SAN FRANCISCO PLANNING DEPARTMENT

Discretionary Review Abbreviated Analysis HEARING DATE: JANUARY 9, 2020

Date: December 27, 2019
Case No.: **2018-003023DRP-02**
Project Address: **2727 Vallejo Street**
Permit Application: 2018.0214.1303
Zoning: RH-1 (D) [Residential House, One-Family- Detached]
 40-X Height and Bulk District
Block/Lot: 0959/022
Project Sponsor: Lewis Butler
 Butler Armsden Architects
 1420 Sutter Street
 San Francisco, CA 94109
Staff Contact: David Winslow – (415) 575-9159
David.Winslow@sfgov.org
Recommendation: **Take DR and Approve with Modification**

6'-0" WITH A SETBACK: VIEW FROM 2737 VALLEJO ST.

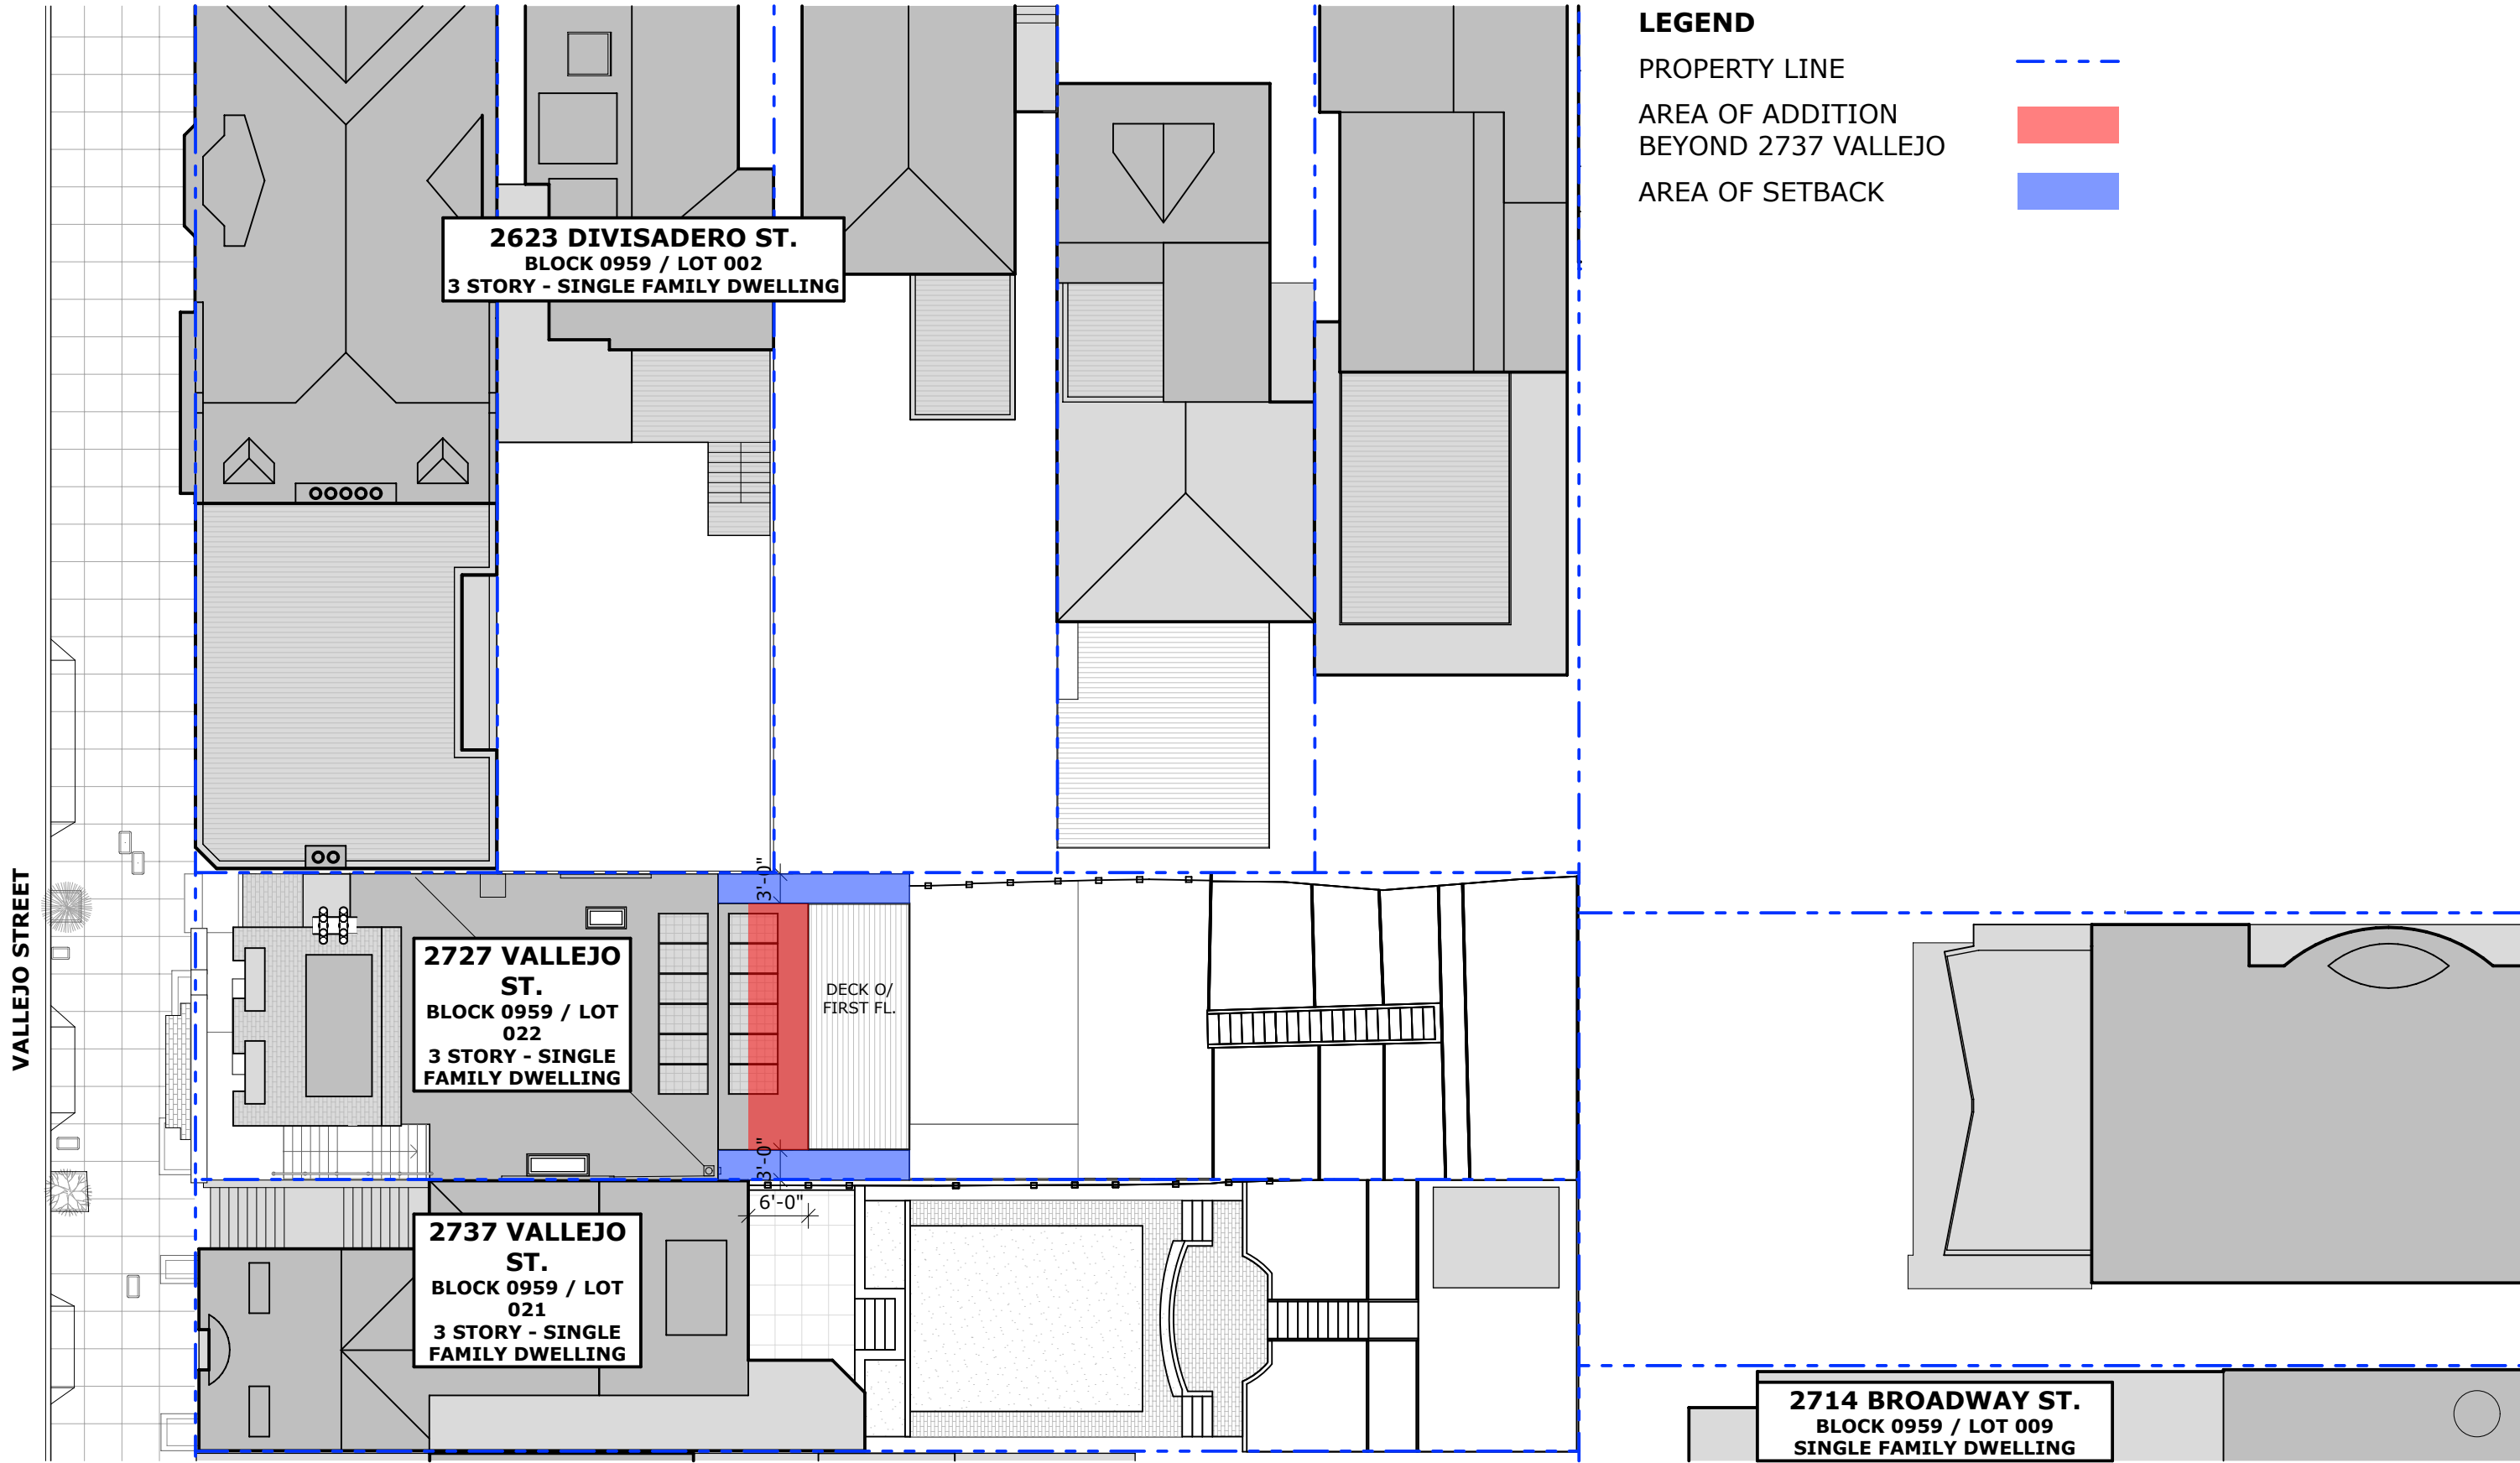
Moreover, the RDAT previously advised that it would only consider a proposal that supports code-complying side yards, and requested that a three-foot side yard setback be provided along the east and west side of the horizontal addition so that a variance from Planning Code Section 133(a)(3) is not required.

- b. Please revise the second and third floor additions to project no more than six feet beyond the adjacent property to the west of the subject property (line F).

3'-0" SETBACK AT SECOND FLOOR, 5'-6" SETBACK AT THIRD FLOOR

6'-0" PROJECTION BEYOND 2737 VALLEJO AT SECOND AND THIRD FLOOR, 3'-0" SETBACK

10'-0" WITH A SETBACK: VIEW FROM 2737 VALLEJO ST.

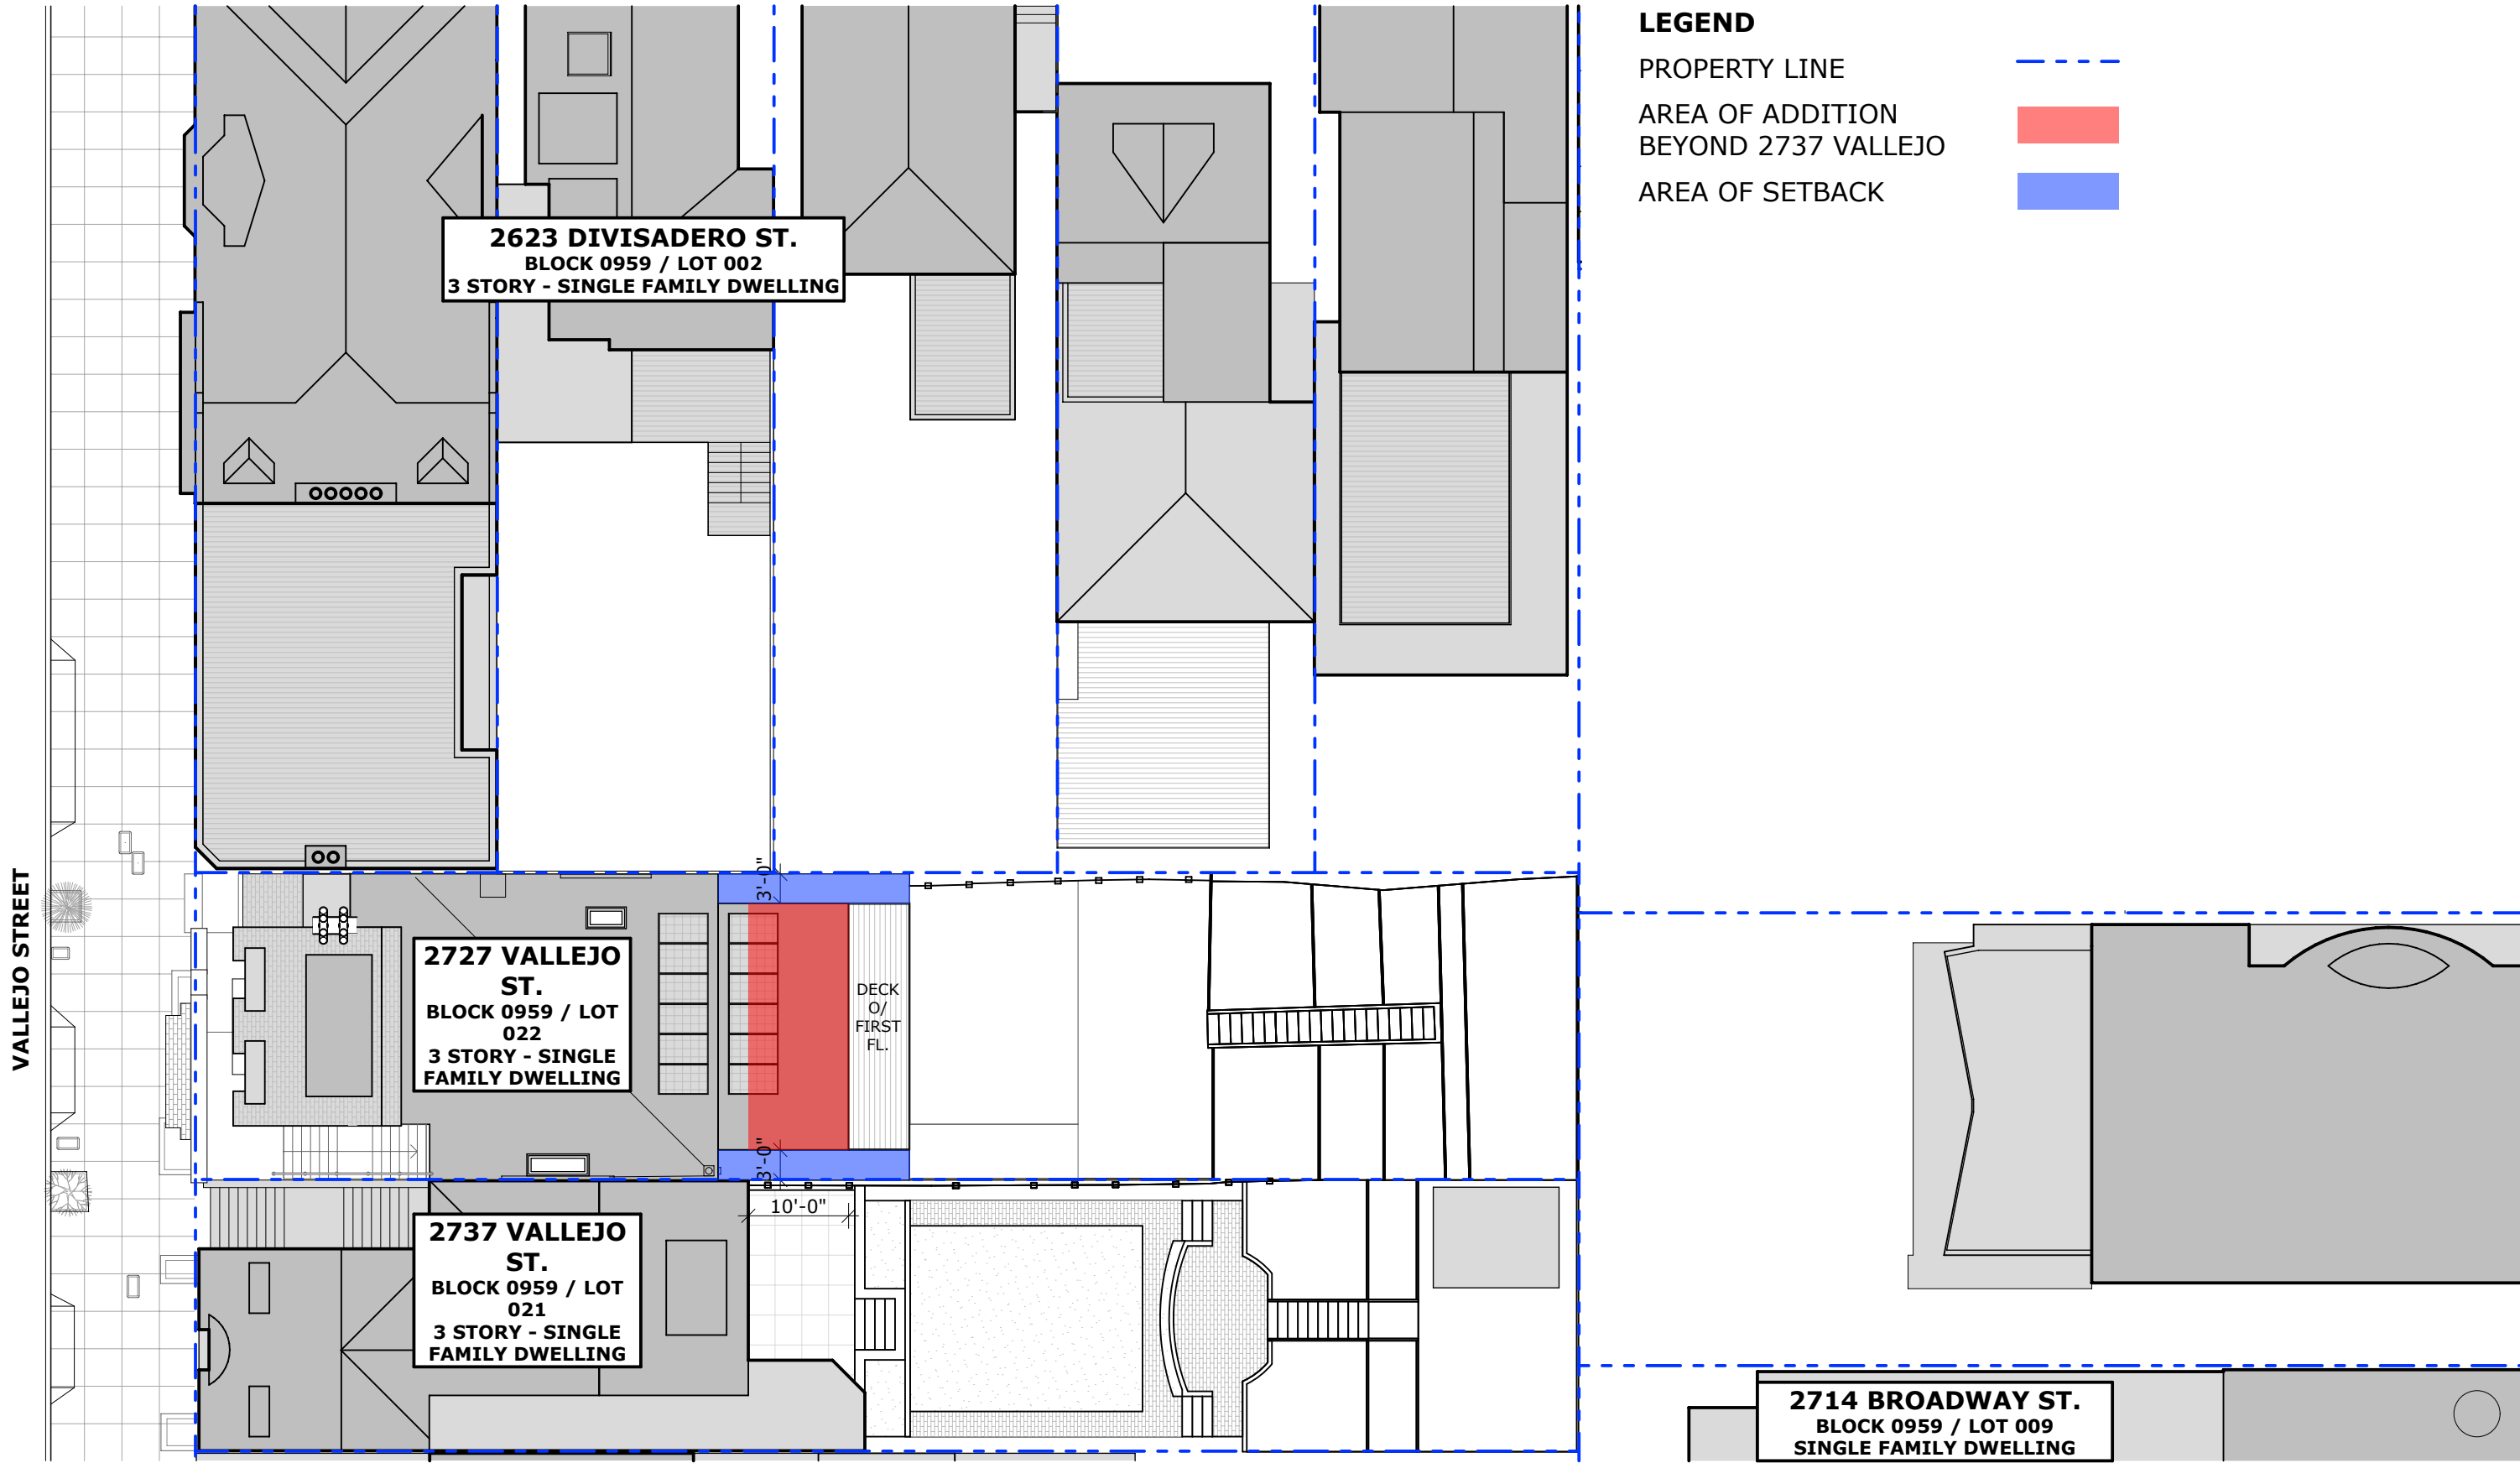
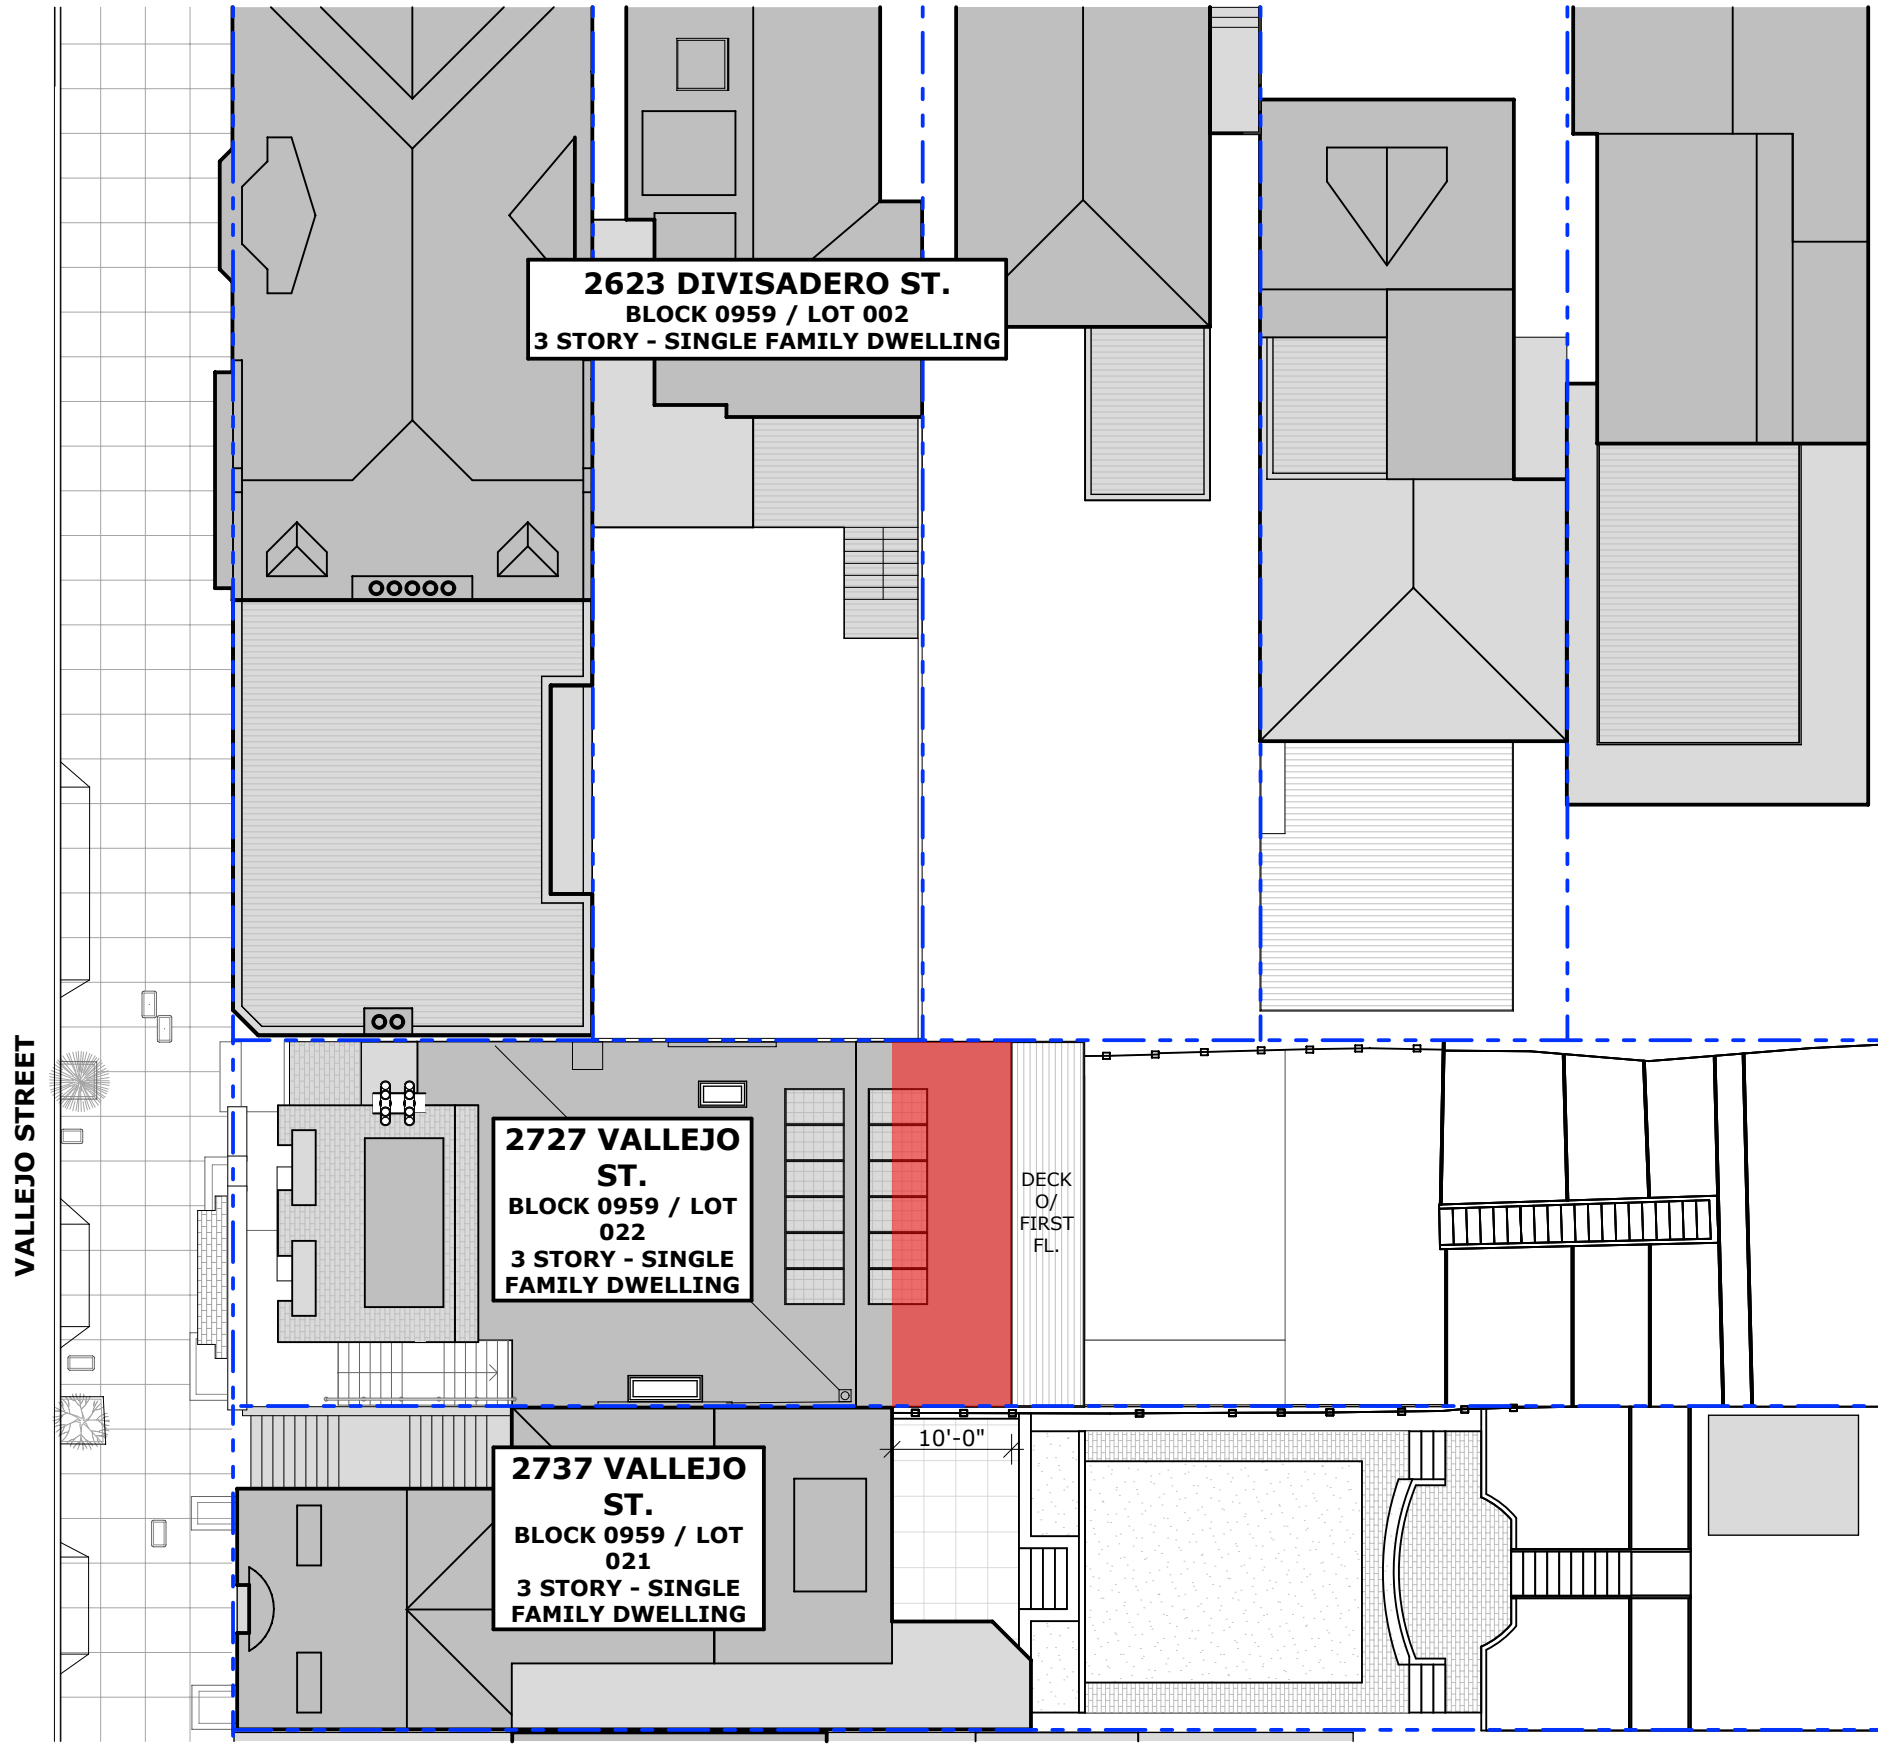
- Include required side yard setbacks of three feet at the first floor to comply with Planning Code requirements and eliminate need for variance
- Reduce horizontal expansion to eight feet beyond the Poole Home to mitigate privacy, light and air impacts and preserve mid-block open space
- Eliminate expansion of existing garage and basement levels to minimize risk of complete demolition
